MARK	DATE	DESCRIPTIONS	REV	CK	CCO#
		REVISIONS			
0	01/25/12	SKYWAY BIKEPATH JOINT COVER PLATES	AM	BM	217S1

CONTRACT CHANGE ORDER NO. 217S1
SHEET 4 OF 7

SAN FRANCISCO OAKLAND BAY BRIDGE
EAST SPAN SEISMIC SAFETY PROJECT
SELF-ANCHORED SUSPENSION BRIDGE
(SUPERSTRUCTURE & TOWER)

SKYWAY BIKEPATH EXPANSION JOINT REPLACEMENT NO. 1

MODIFICATION TO PIPE SUPPORT PS-19 AT HINGE B & C

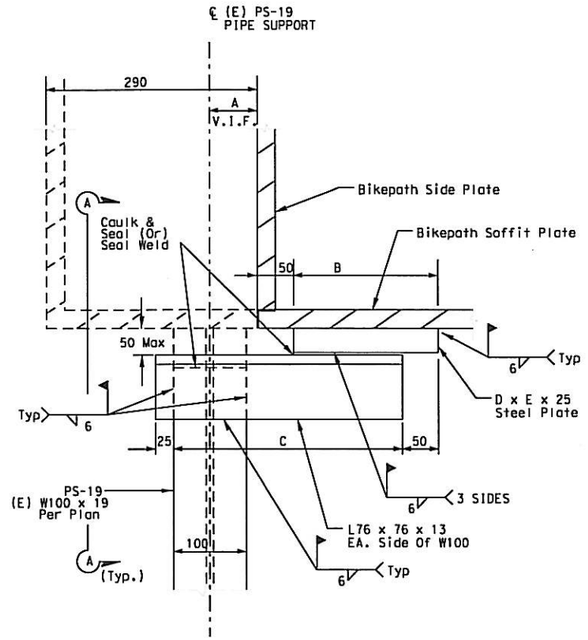
1. Detail is modifications to attachment of Skyway pipe support PS-19 located at hinges indicated. Refer to contract 012024 for details of standard pipe support and piping configuration

PLAN
(Box panel at Expansion Joint - Hinge D) (See Note 1)
1:30

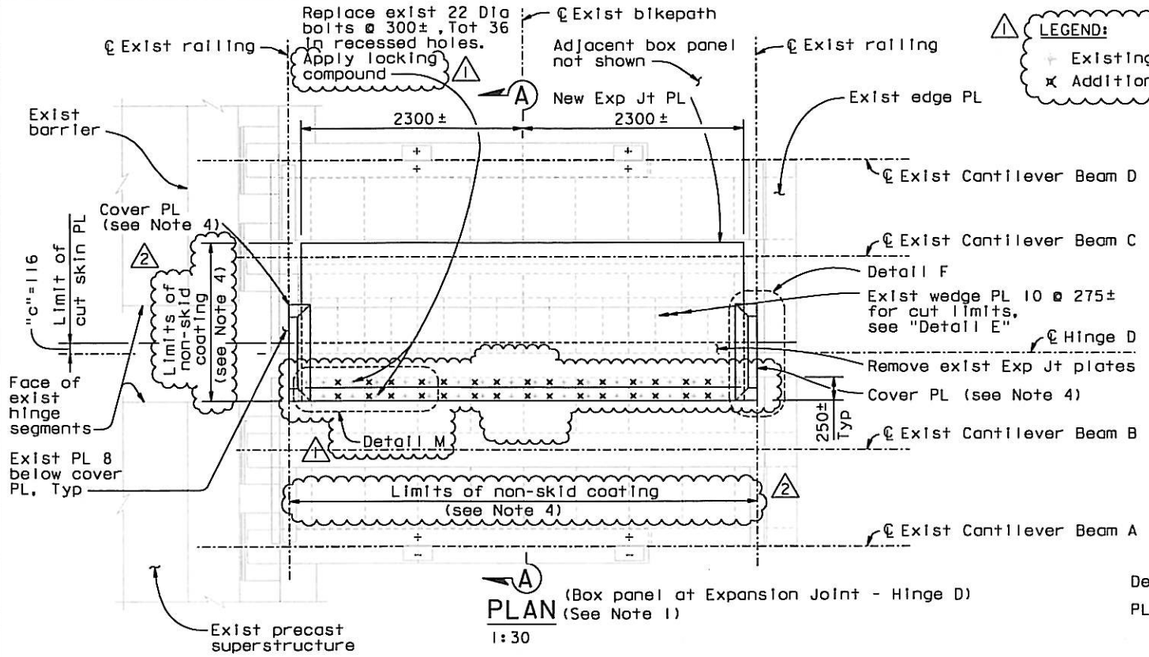
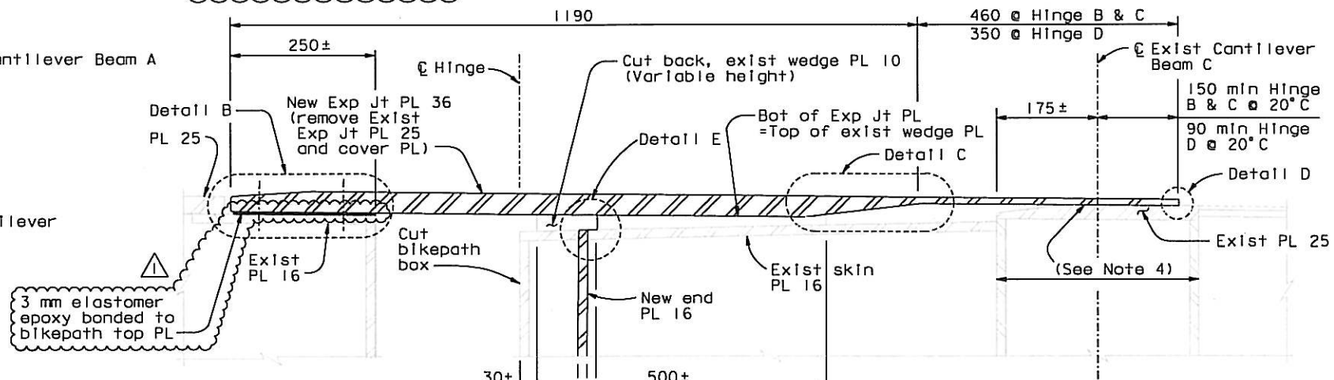
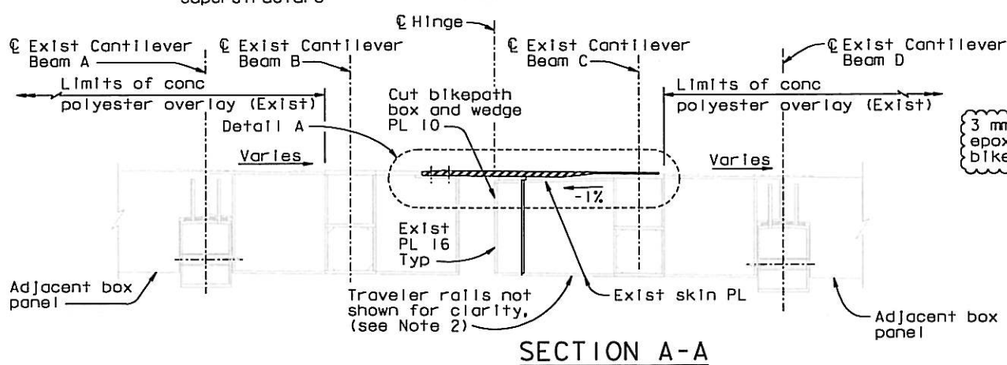
4. Top surface of exposed plates shall have non-skid coating, to be performed by Others. The non-skid coating shall match the existing color pattern.
   ⚠3 Where the tapered edge cover plate extends over the existing white edge of the bikepath panel, white finish paint shall be used in lieu of non-skid.

5. Slope shall match the slope of exist top PL 25 of Cantilever Beam C.
6. Location and dimension of the countersunk holes shall be verified to match with exist holes in exist PL 16 and exist expansion joint plate.
   ⚠1 All the plates cut shall be ground square. For details, see "Skyway Bikepath Expansion Joint Replacement No.2" sheet.

PLAN (Box panel at Expansion Joint - Hinge B)
1:25

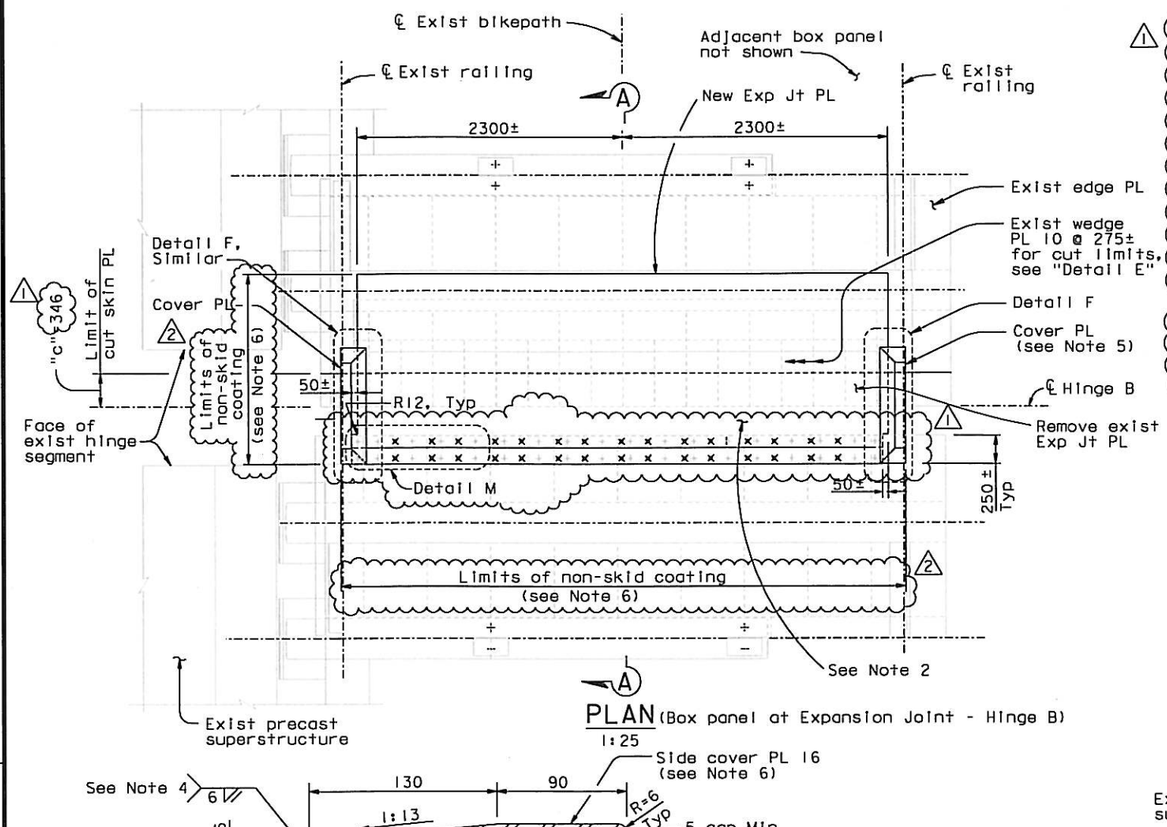
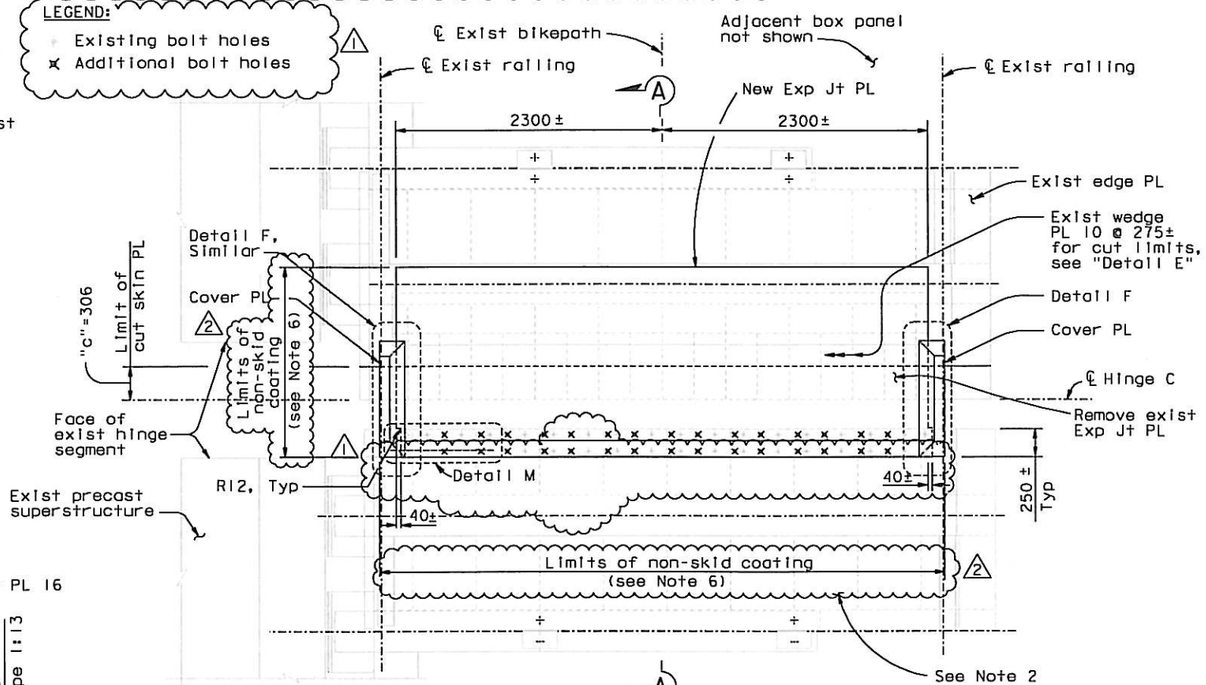
4. Terminate the weld 12 mm short of the expansion joint PL taper at the bolted end. Caulk the space between the cover PL and the expansion joint PL at the tapered end of the expansion joint PL. At the Contractor's option, the weld between expansion joint PL and cover PL may be field weld.
5. Trim the cover PL as necessary to clear the expansion joint PL bolted connection.
6. Top surface of the exposed plates shall have non-skid coating, to be performed by Others. The non-skid coating shall match the existing color pattern. Where the tapered edge cover plate extends over the existing white edge of the bikepath, white finish paint shall be used in lieu of non-skid.
7. Tap holes in existing top PL of bikepath panel at every other bolt (Total 66 bolts).
8. Top of silicone joint seal shall be no more than 6 mm lower than top of Expansion Joint plate.

PLAN AT HINGE AE

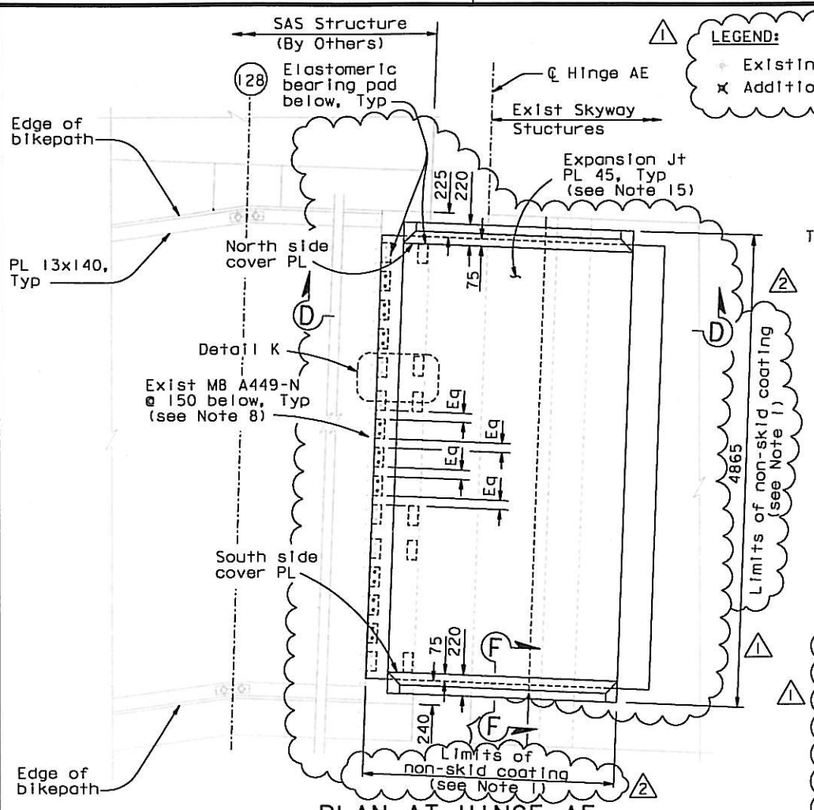
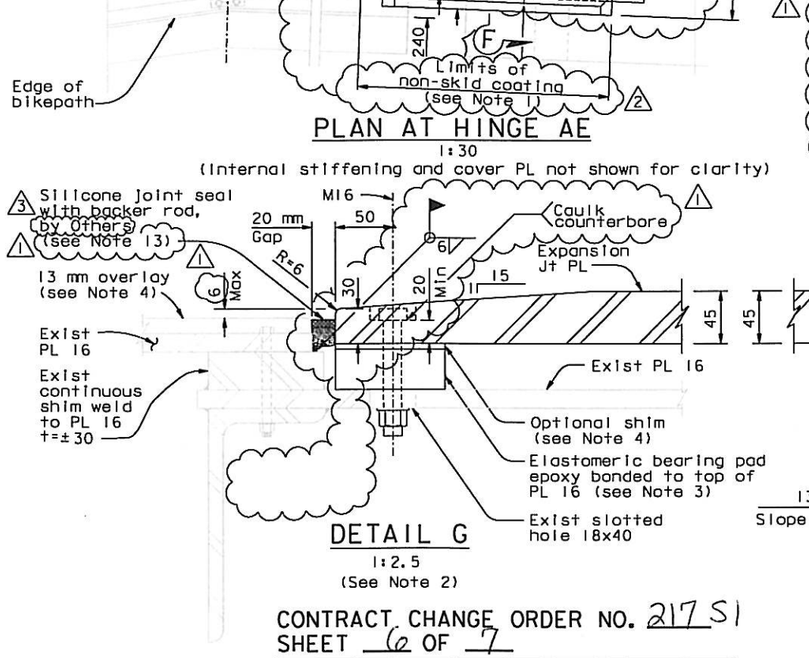
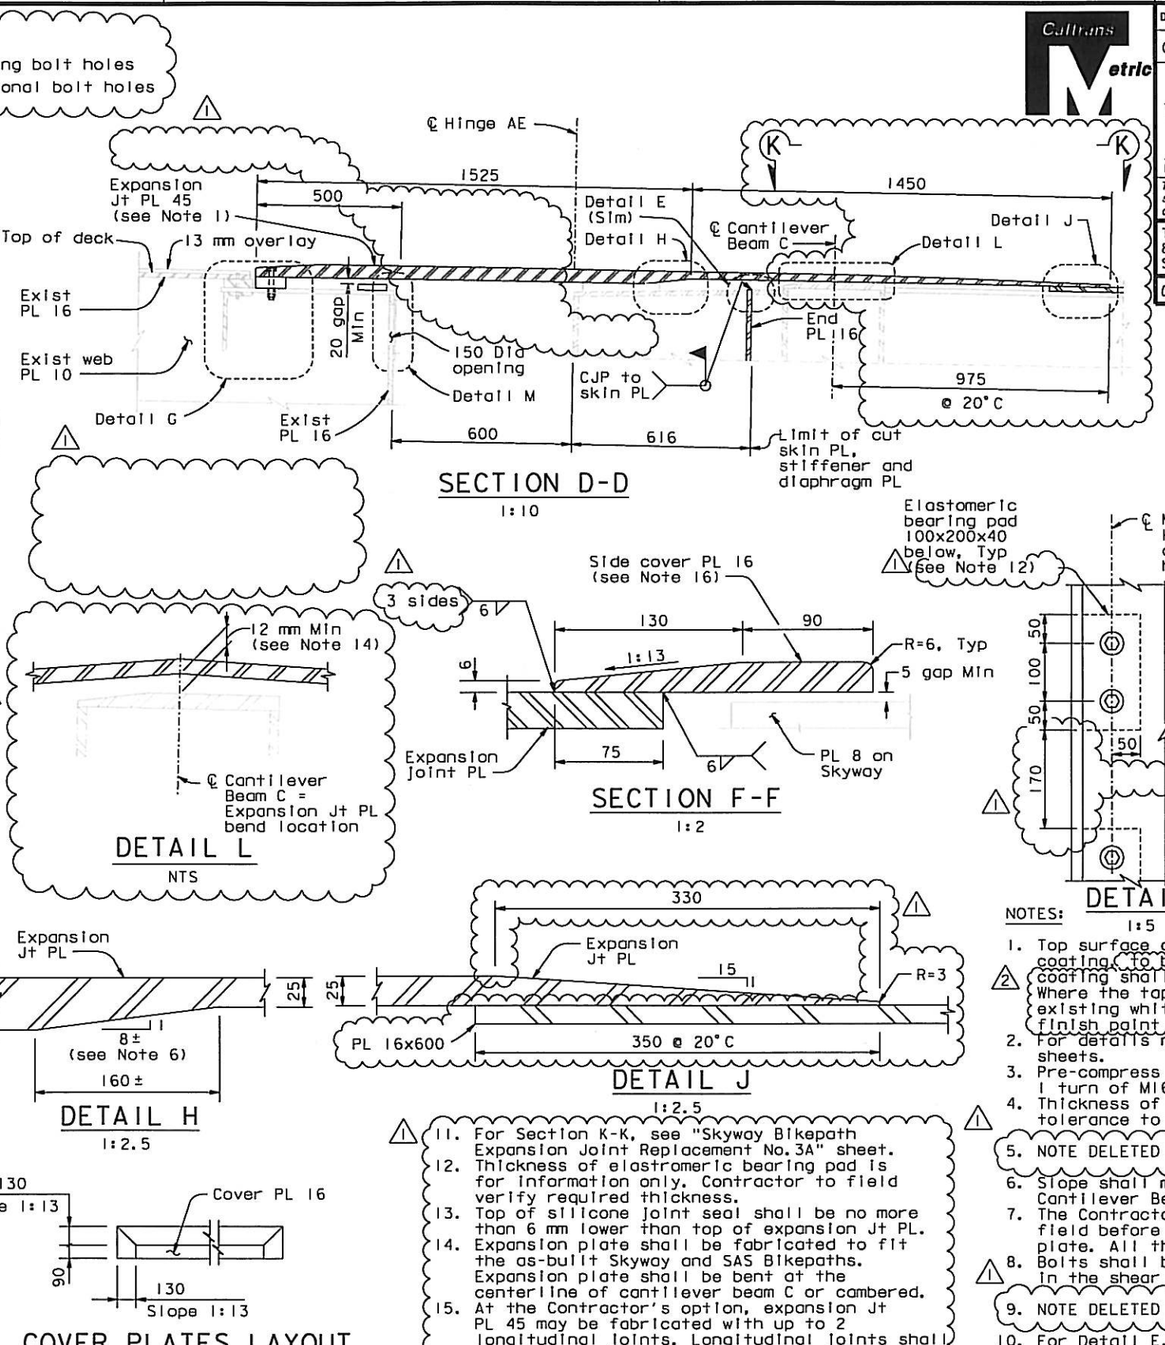
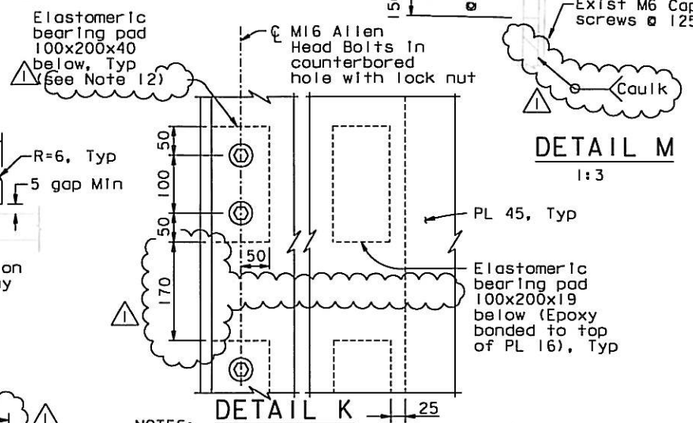
1. Top surface of exposed plates shall have non-skid coating (to be performed by Others). The non-skid coating shall match the existing color pattern. Where the tapered edge cover plate extends over the existing white edge of the bikepath panel, white finish paint shall be used in lieu of non-skid.

13. Top of silicone joint seal shall be no more than 6 mm lower than top of expansion Jt PL.
14. Expansion plate shall be fabricated to fit the as-built Skyway and SAS Bikepaths. Expansion plate shall be bent at the centerline of cantilever beam C or cambered.

SECTION K-K

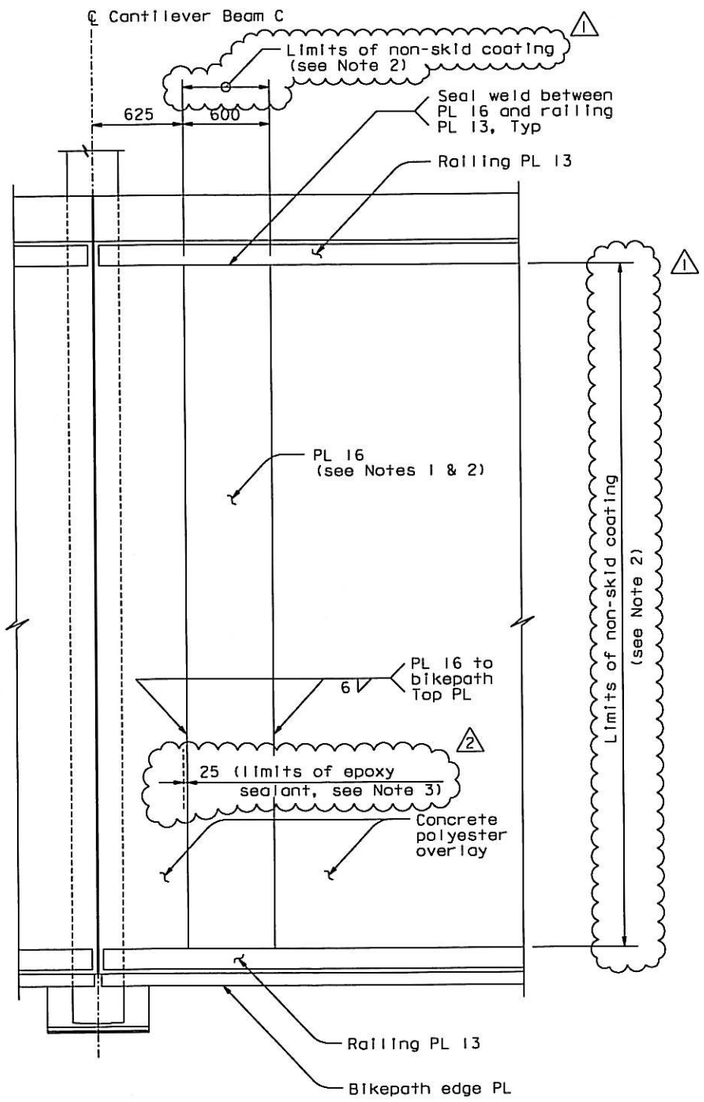
1. Remove concrete polyester overlay before placing PL 16. Polyester overlay in the vicinity of PL 16 shall be replaced / repaired as needed. (2)
2. Top surface of PL 16 not covered by expansion joint plate shall have non-skid coating, to be performed by Others. (2)
   The non-skid coating shall match the existing color pattern. Where the tapered edge cover plate extends over the existing white edge of the bikepath panel, white finish paint shall be used in lieu of non-skid. (1)
3. At the Contractor's option, 25 mm of the replaced/repaired concrete polyester overlay may be substituted with epoxy sealant. (2)
